Re: 581 American Legion Highway, DEP file number 006-1882

The attached materials and this letter represent a response to issues raised at our last hearing for the project at 581 American Legion Highway. The following is a summary of issues raised in bold italic and our response in plain text.

581 American Legion Highway Vegetation Management Plan

1 ARCHITECTURAL SITE PLAN
1/16" = 1'-0"

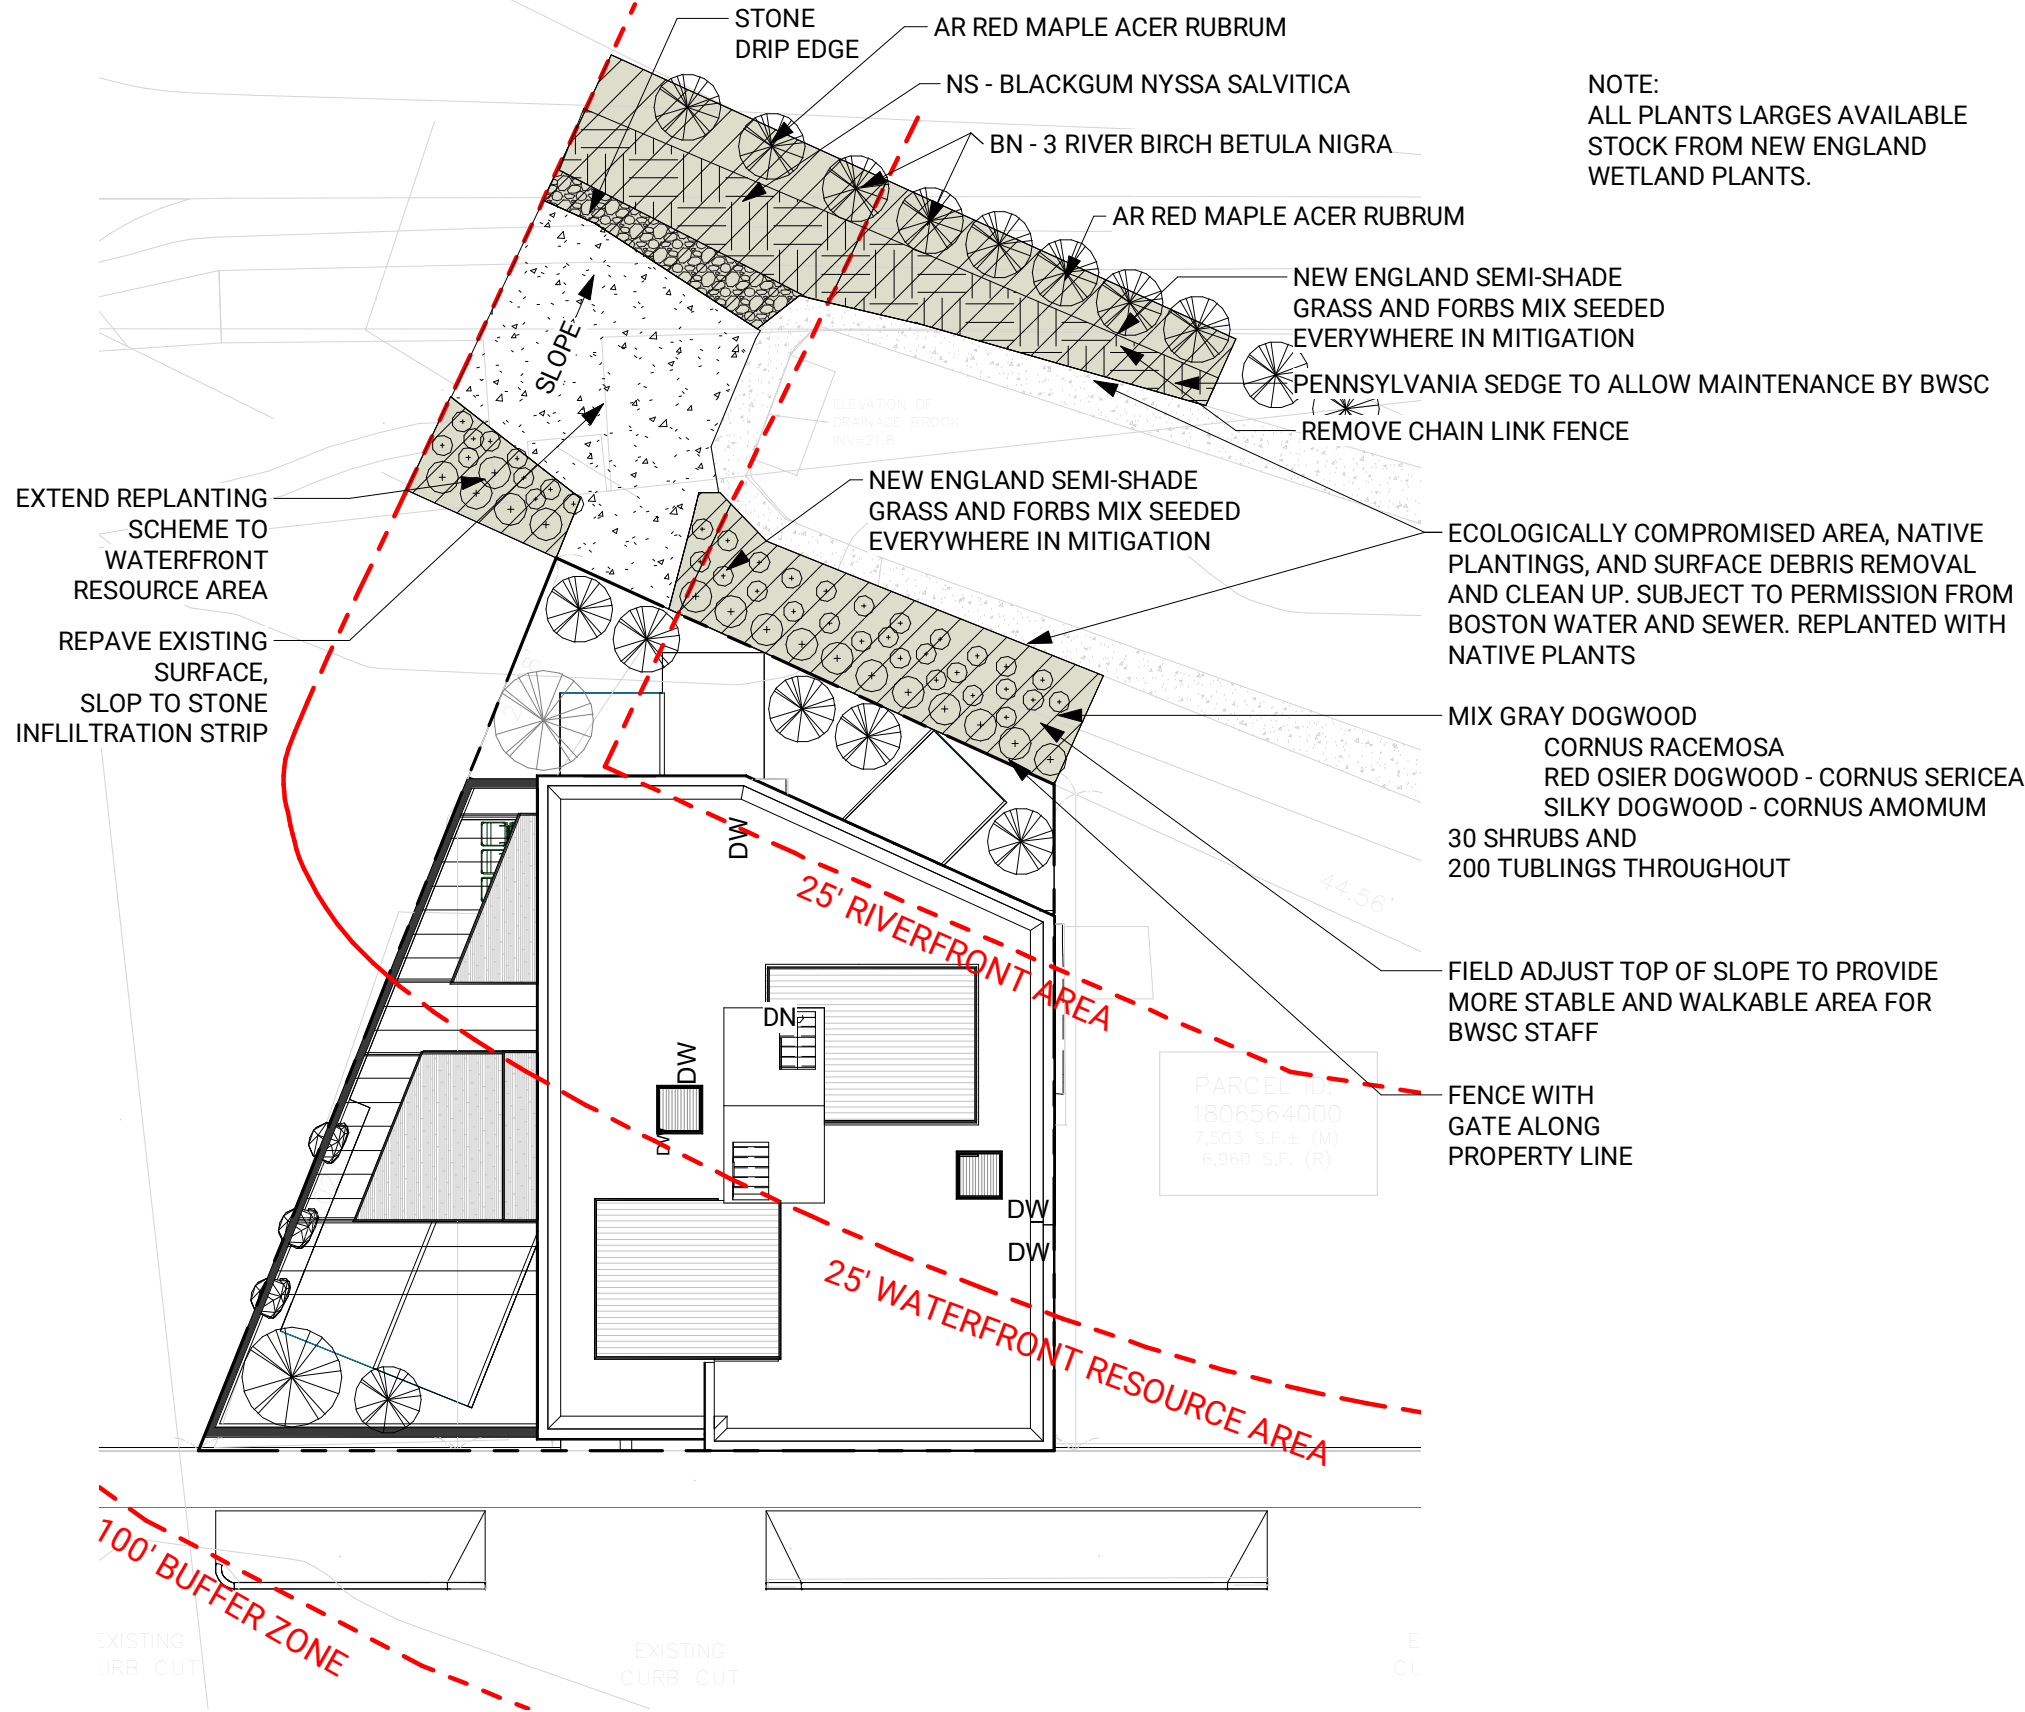
A revised planting that provides BWSC the necessary access to their easement based on communications with BWSC.

We met with BWSC on site to better understand how they need to access certain areas of the site and have revised the plans accordingly. The main changes are as follows:

1. We will leave the area near the headwall paved. However, we will coordinate with BWSC to repave this area so it is superelevated towards a drip trench on the north side of the easement. Currently the pavement pitches towards the headwall and any water would flow untreated into the Brook. This repaving will also remove a pavement bump right at the headwall that sometimes makes work for BWSC staff a little rough when their equipment operates in this area. BWSC needs this surface

paved so they can operate equipment to clean out the brook at the inlet to the pipe (outlet to the open brook).

2. We are keeping an area of Pennsylvania sedge as a foot path for BWSC staff who use the northern side of the easement to clean things out of the brook since the southern side of the easement is much steeper.
3. We will bring in an arborist to evaluate all native trees in the easement and coordinate with BWSC to remove any hazards.
4. We have extended our plantings along the north side of the pavement within the Waterfront Resource area to somewhat offset the pavement remaining.
5. In the portion of the easement currently on the other side of the fence at 581 American Legion Highway, we will soften the slope a little to make the southern side easier for BWSC staff to walk and provide a more stable slope. This portion of the work will be monitored by the wetland scientist and coordinated with BWSC.

NOTE: IN BWSC EASEMENT AREA REMOVE ANY INVASIVE OR HAZARD TREE AND REPLACE WITH SMALLER TREES OR SHRUBS. LOW DENSITY PLANTING TO ENSURE ACCESS BY BWSC

1 ARCHITECTURAL SITE PLAN - MITIGATION PLAN FOR BOTH PLOTS
1/16" = 1'-0"

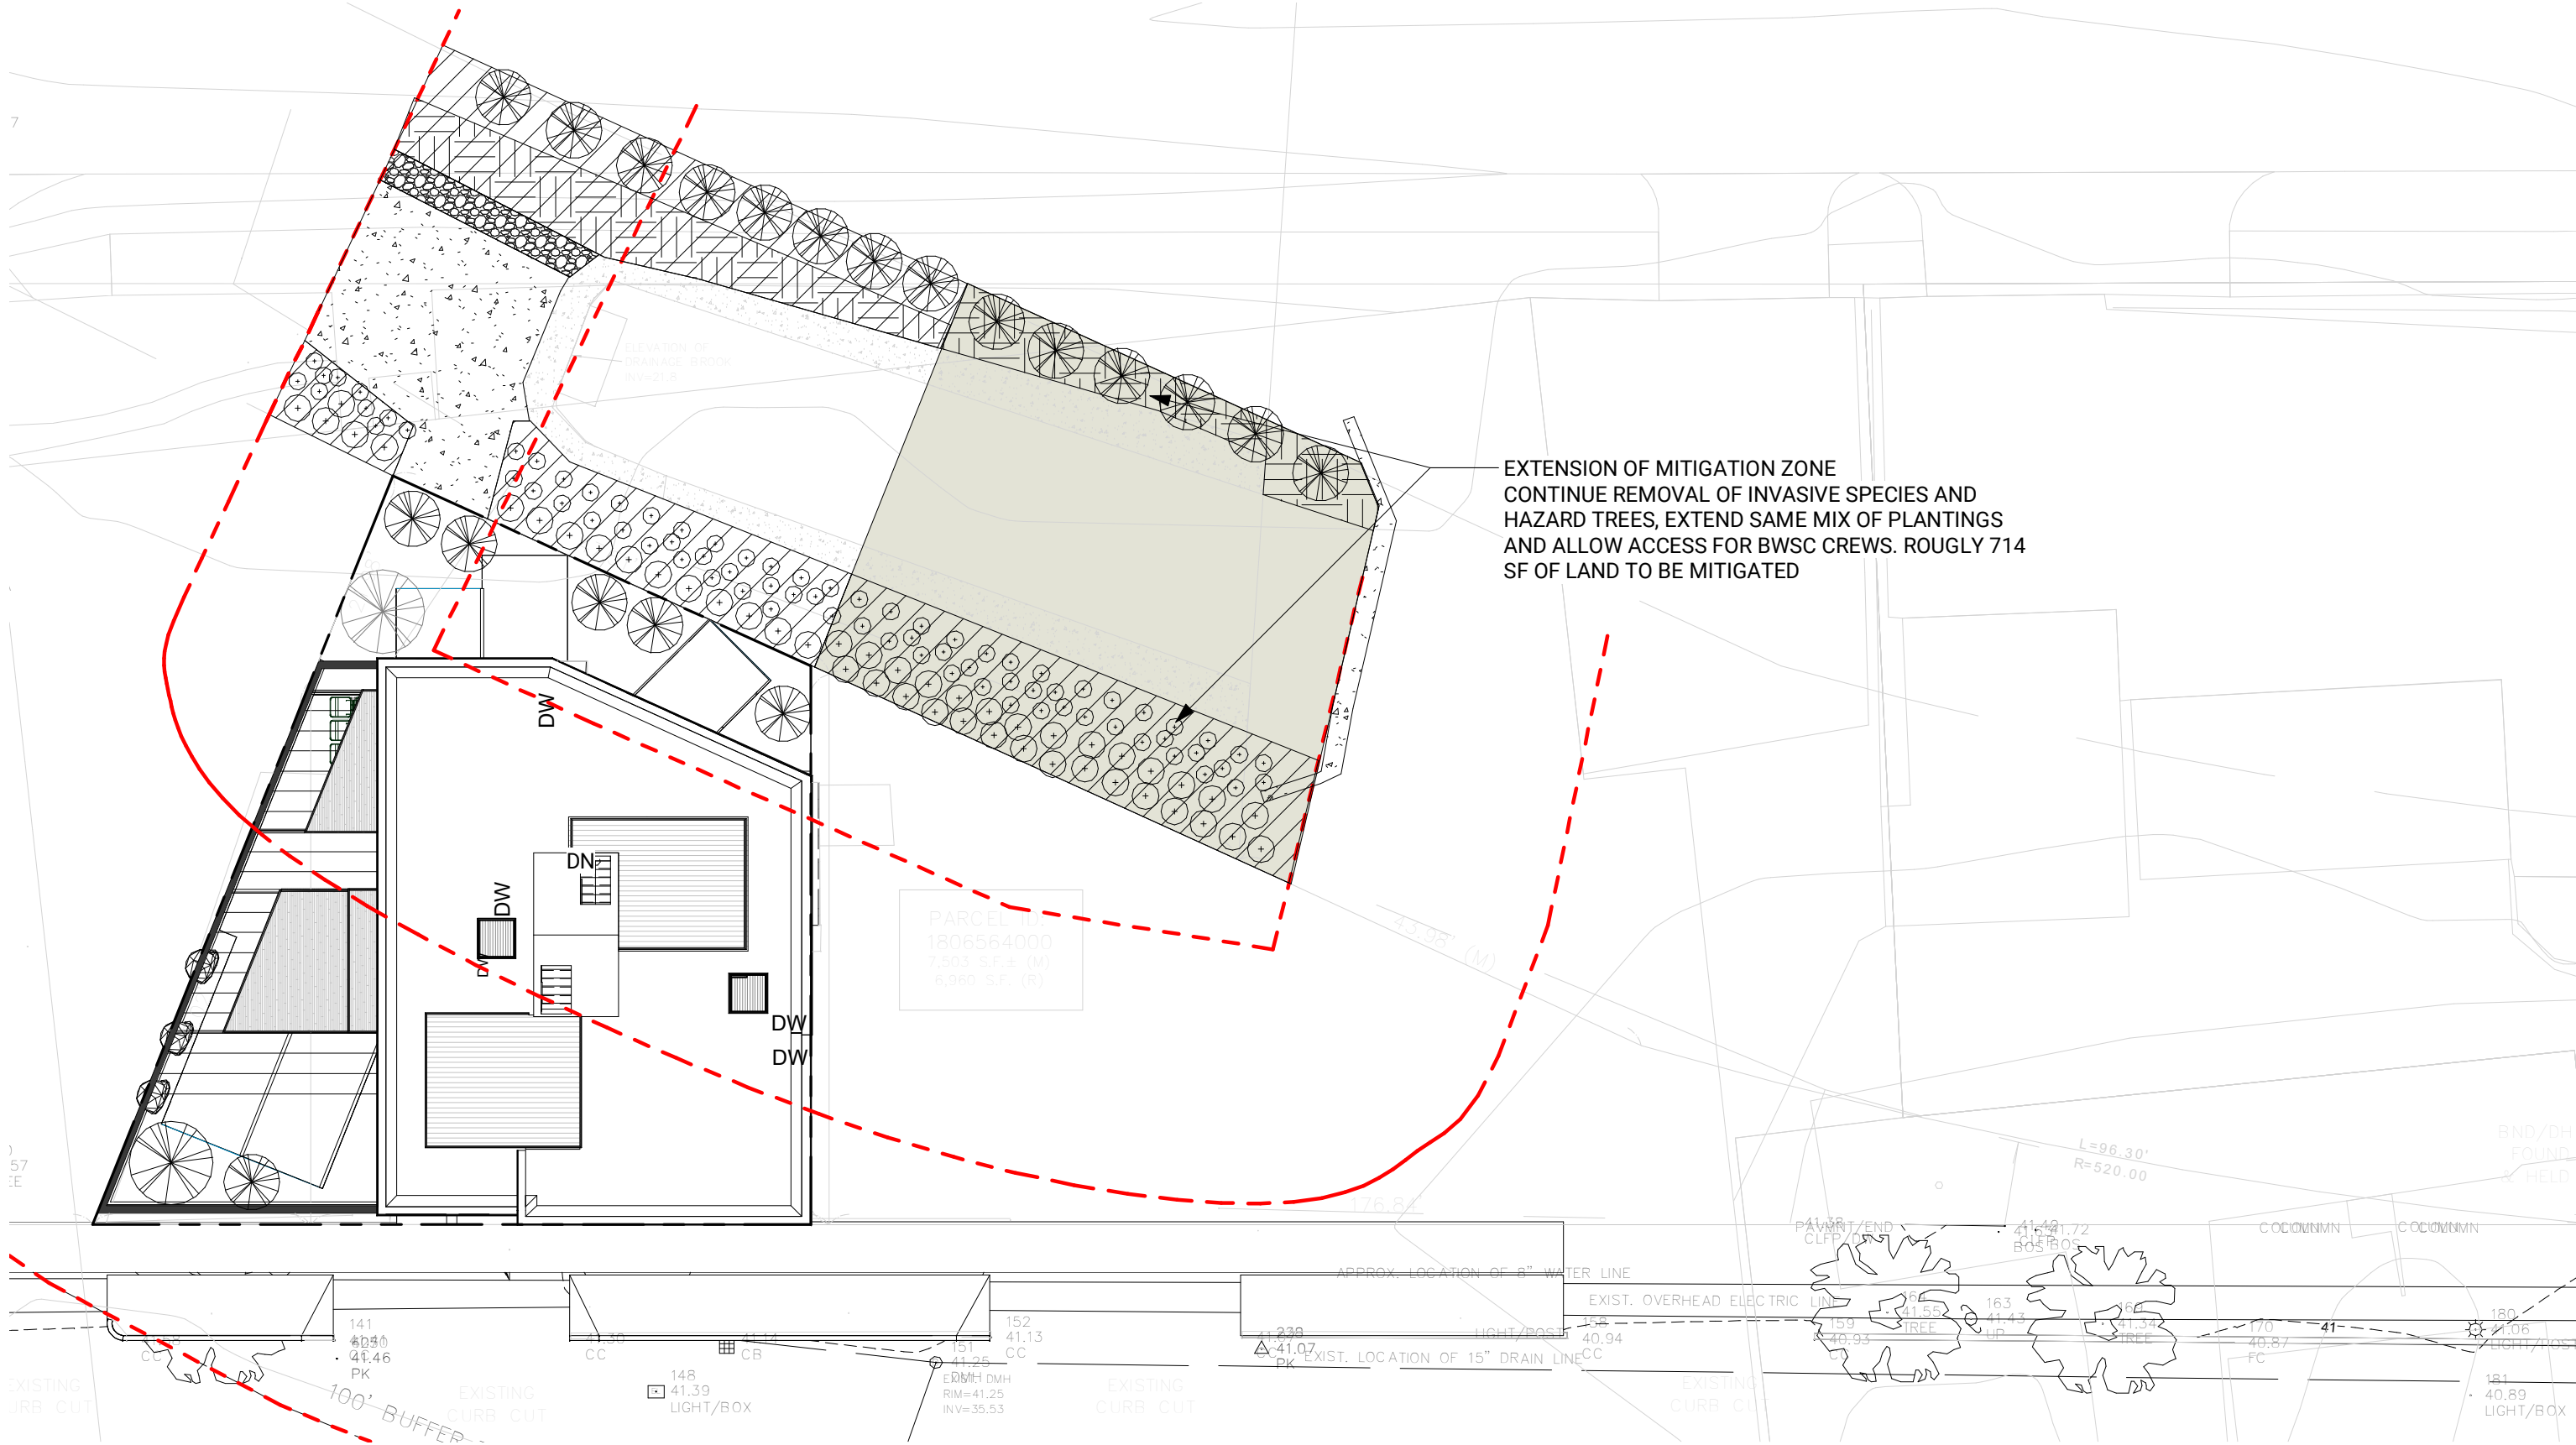
A concept plan for proposed mitigation on Lot 2.

The concept plan for lot 2 is attached. This concept would be refined and subject to a separate Notice of Intent, but gives a sense of how this resource area can be improved once both lots are redeveloped.
